Wayzata Planning Commission

Monday, February 22, 2016

Date: February 19, 2016
To: Planning Commission
From: Jeff Thomson, Director of Planning and Building
Subject: Huntington Heights Subdivision, 173 Huntington Ave S

PRELIMINARY PLAT
EROSION CONTROL/GRADING PLAN
TREE SURVEY
 PREPARED FOR:
BRUNO SILKOWSKI

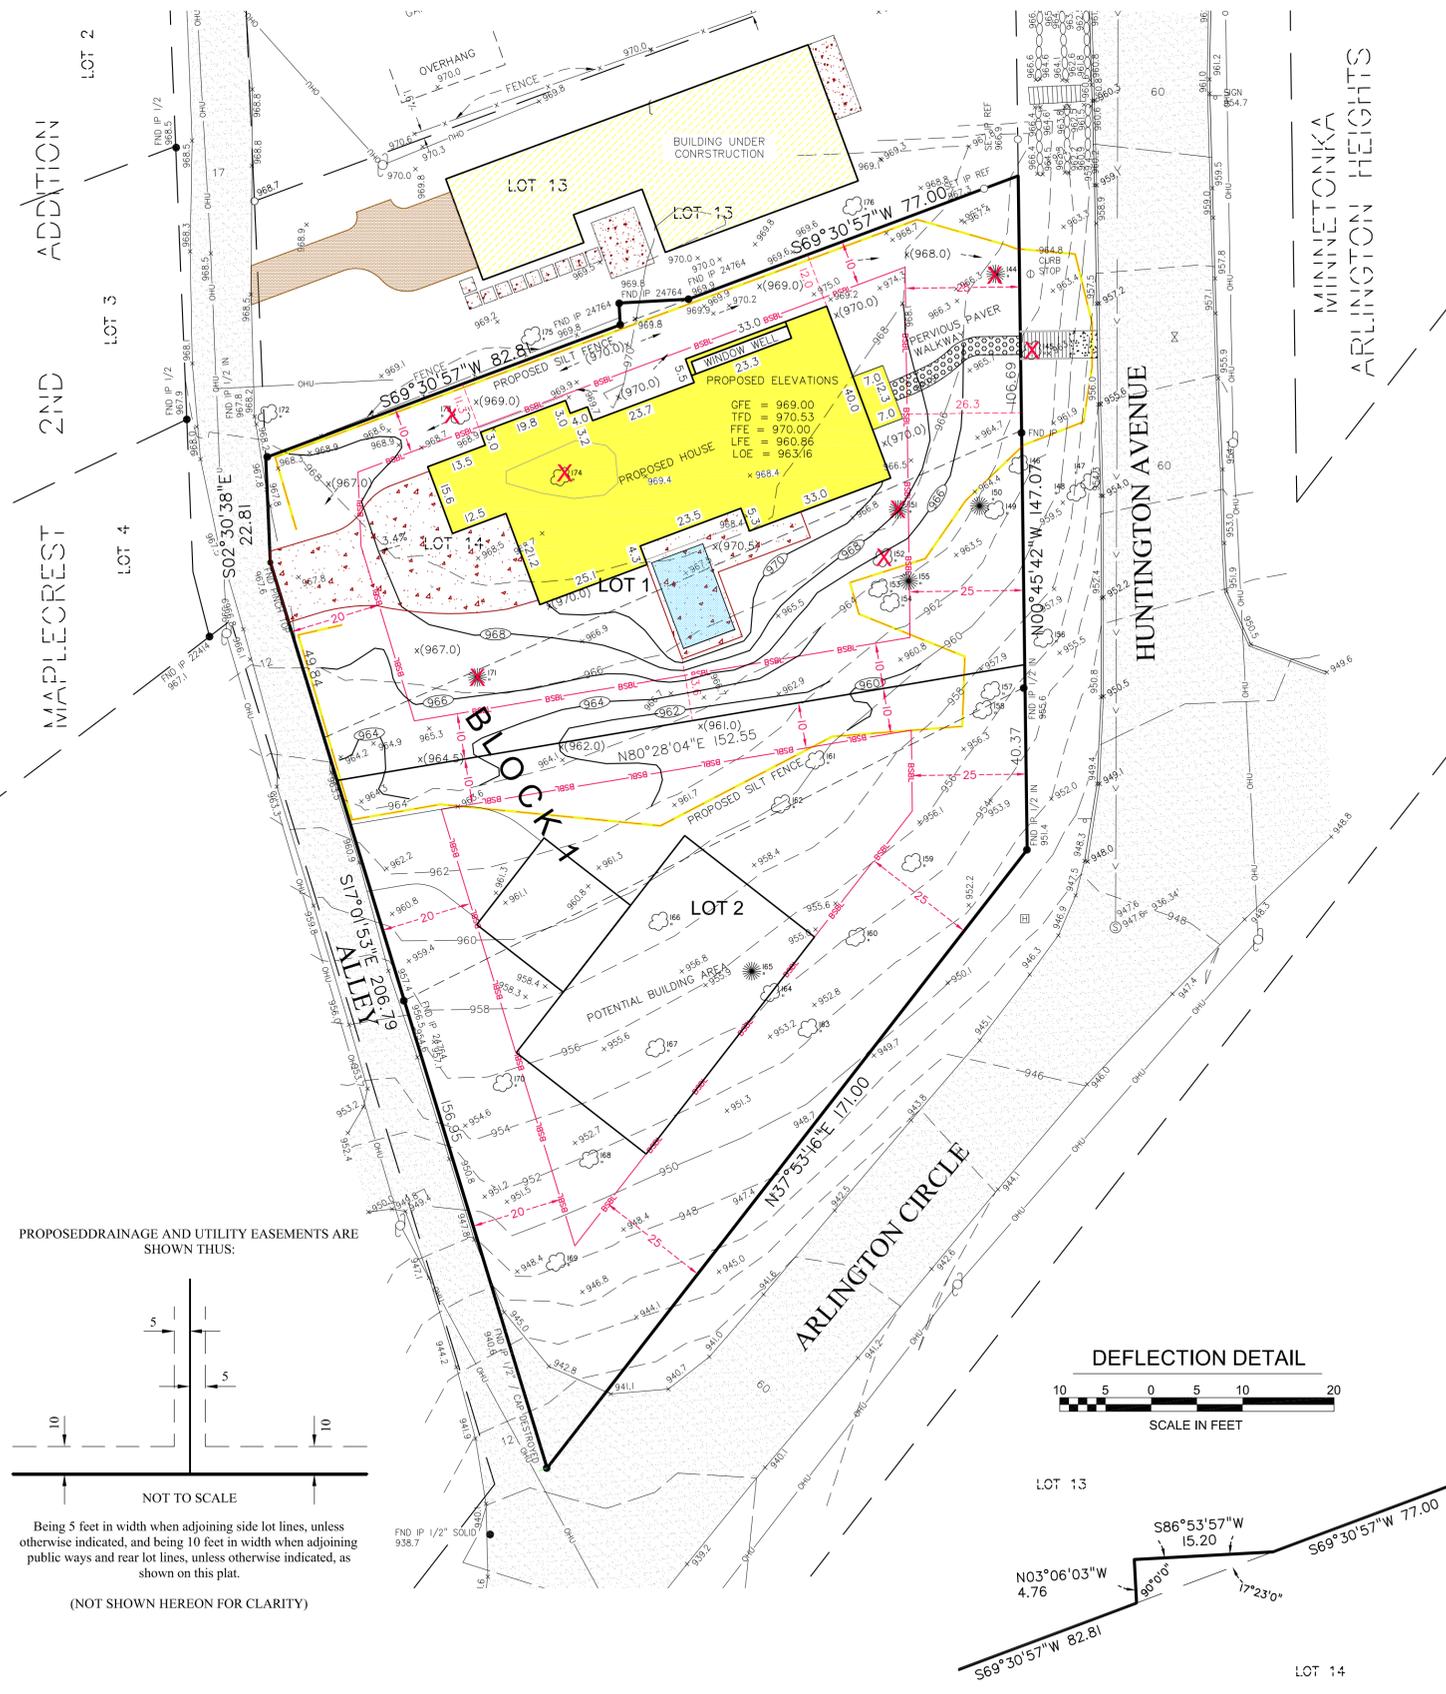
City staff has reviewed the tree preservation plan and believes there is an opportunity to preserve additional trees on Lot 1. Trees 144 and 171 are outside of the footprint of the proposed house, but would be removed based on the proposed grading. Staff believes there is an opportunity to adjust the site grading in order to preserve these two additional trees, and minimize grading within the critical root zone area.

- F. The grading plan for Lot 1 must be revised with the building permit application to preserve the significant trees identified as #144 and #171 on the tree survey, subject to review and approval by the city engineer.
